# Work Order ID 96763

Item Name: Crosstube Assembly, Mid Fwd

DRAWING NO. D206-667-147	TITLE CROSSTUBE ASS'Y (206L MID FWD)	REV. A	<b>DART AEROSPACE LTD ENGINEERING ORDER</b>		D.E.O. NO. D206-667-147-A-1	SHEET NO. SHEET 1 OF 1	SCALE NTS
DRAWN <i>qp</i>	CHECKED <i>AS</i>	MFG. APPR. <i>AS</i>	APPROVED <i>MD</i>		DE APPR. <i>MD</i>		
DATE 11.07.15	DATE 11.07.20	DATE 11.07.21	DATE 11/07/21		DATE 11.07.21

DRAWING NO. D206-667-147		TITLE CROSSTUBE ASS'Y (206L MID FWD)		REV. A		DART AEROSPACE LTD ENGINEERING ORDER		D.E.O. NO. D206-667-147-A-2		SHEET NO. SHEET 1 OF 1		SCALE NTS	
DRAWN AJS		CHECKED		MFG. APPR. <i>E</i>		APPROVED <i>NO</i>		DE APPR. <i>NO</i>					
DATE 12.08.02		DATE 12.08.02		DATE 12.08.02		DATE 12.08.02		DATE 12.08.02		DATE 12.08.02

**DETAIL P**  
 BONDING STRAP INSTALLATION 2 PL

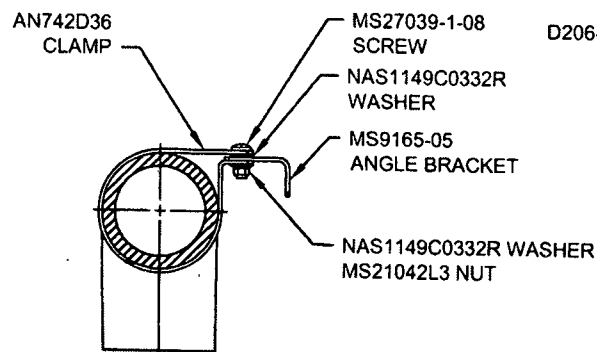
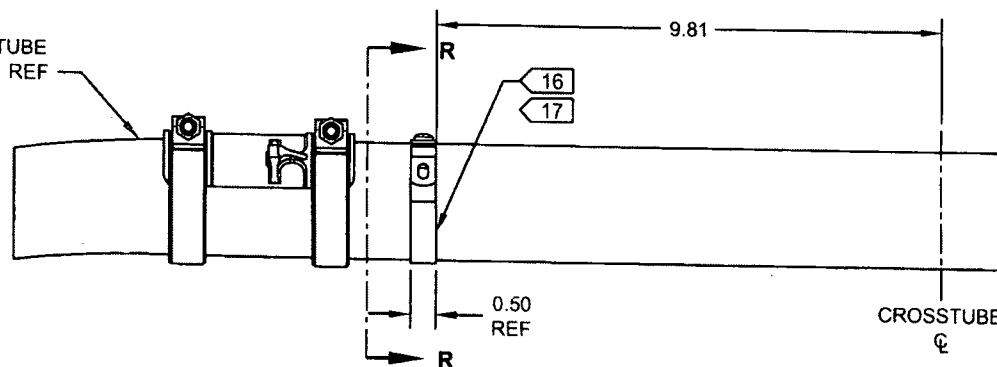
**PURPOSE:**

ADD ELECTRICAL GROUNDING STRAP

ITEM	QTY -147	PART NUMBER	DESCRIPTION
1	X	D206-667-147	CROSSTUBE ASSEMBLY (206L MID FWD)
10	2	AN742D36	CLAMP
11	2	MS9165-05	ANGLE BRACKET
12	2	MS21042L3	NUT (OR MS21042-3)
13	2	MS27039-1-08	SCREW
14	4	NAS1149C0332R	WASHER (OR AN960C10L)

- 16) MASK AREA UNDER CLAMP PRIOR TO PAINTING  
 17) SEAL EDGES WHERE AN742D36 CLAMP MEETS WITH THE CROSSTUBE USING SIKAFLEX-241/291 OR MIL-S-8802 CLASS B2 OR PROSEAL 890 SEALANT  
 18) PERFORM RESISTANCE CHECK TO ENSURE MAX RESISTANCE IS 10 MILLIOHMS
